IMPROVED GUN DESIGN

OLD GUN DESIGN

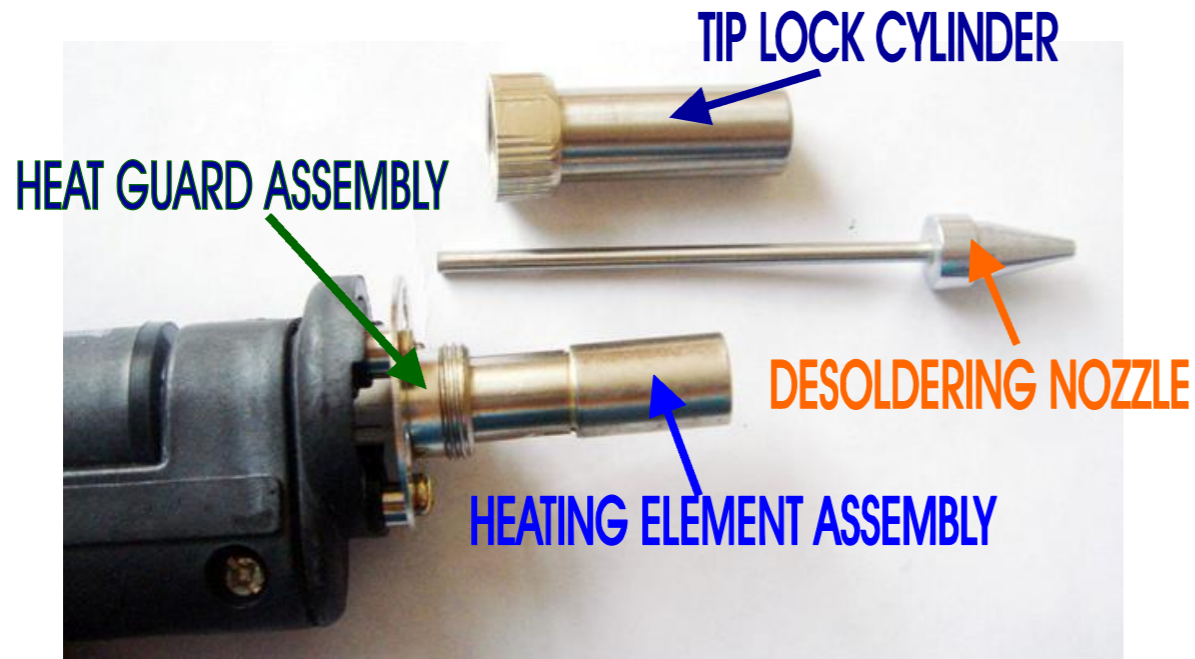
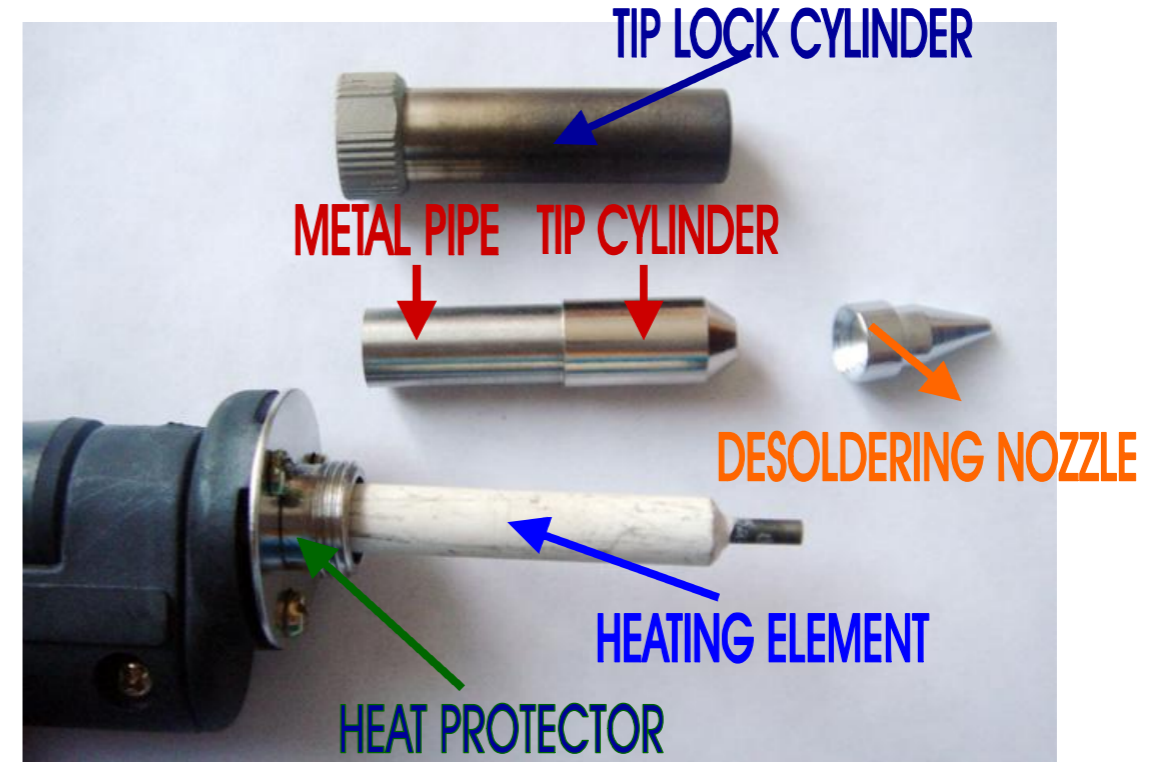
New design gun has three types:

- *B1002A* for Aoyue 474A+ and Aoyue 701A+ (24V)
- *B1002B* for Aoyue 474 and Aoyue 701 (36V)
- *B1003A* compatible with Aoyue Int2702 and Aoyue Int2702A+.

Old design gun has two types:

- *B1002* for Aoyue 474 and Aoyue 701 (36V)
- *B1003* for Int2702.

Old design has two model numbers:

- *C005* used in B1002 gun
- *C006* used in B1003 gun

New design has three model numbers:

- *C005A* used in B1002A gun
- *C005B* used in B1002B gun
- *C006A* used in B1003A gun

Old design used in B1002 and B1003 gun.

- 202082 (1.5mm)
- 202092 (1.0mm)
- 201212 (1.8mm)

New design used in B1002A, B1002B and B1003A.

- 302082 (1.0mm)
- 302092 (1.5mm)
- 301212 (1.8mm)

OLD HEATING ELEMENT AND NOZZLES WILL BE DISCONTINUED, FOR OLD GUNS TO ADAPT TO NEW NOZZLES AND HEATING ELEMENT, THE TIP LOCK CYLINDER AND HEAT PROTECTOR SHOULD BE CHANGED.
